Submission to Sydney Metro - Sydenham to Bankstown Mod 1 - Bankstown Station

Regarding the Revised station design for Bankstown Station. Includes the provision of a new north-south connection across the rail corridor between Appian Way and Restwell Street.

From Mathew Hounsell - June 2020

FIGURE 5.1

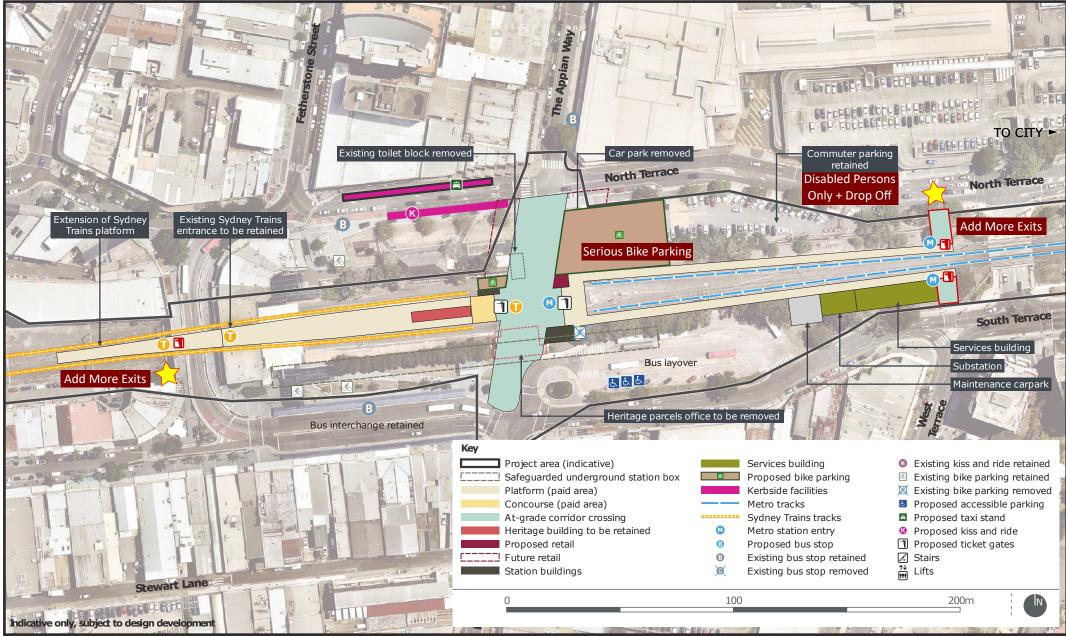
Secondly, the proposed design risks negative interactions due to key features of passenger behaviour in Sydney. This design will ensure that there is crowding and congestion at the ticket gates. **Sydney residents locate themselves on trains to minimise walking distance**. Thus, the front carriages of arriving trains and metros will fill with passengers. In addition, at other stations on the network, passengers will move to board the front carriages causing congestion. This is not a theoretical problem; it is a practical problem that constantly causes delays across the Sydney Trains network. This is a fundamental of station design, and it is confounding to see that in NSW this fundamental is still ignored.

In addition, there the revised design shown no emergency exit at the edges of the station, even though those were shown in the original design.

Therefore, to 1) reduce crowding, congestion, and delays, 2) improve fire and life safety, and 3) increase patronage; I would recommend the instillation of exits on the eastern end of the metro station. These eastern exits would allow quick exit in the event of an emergency. These eastern exits would spread passengers more evenly on the trains. These eastern exits would attract passengers from further afield and connect all passengers quickly to more locations. These eastern exits might allow some bus stops to be relocated to improve network efficiency.

Similarly, an exit onto Bankstown City Plaza from the Train platform would increase safety, reduce congestion, and increase the catchment area.
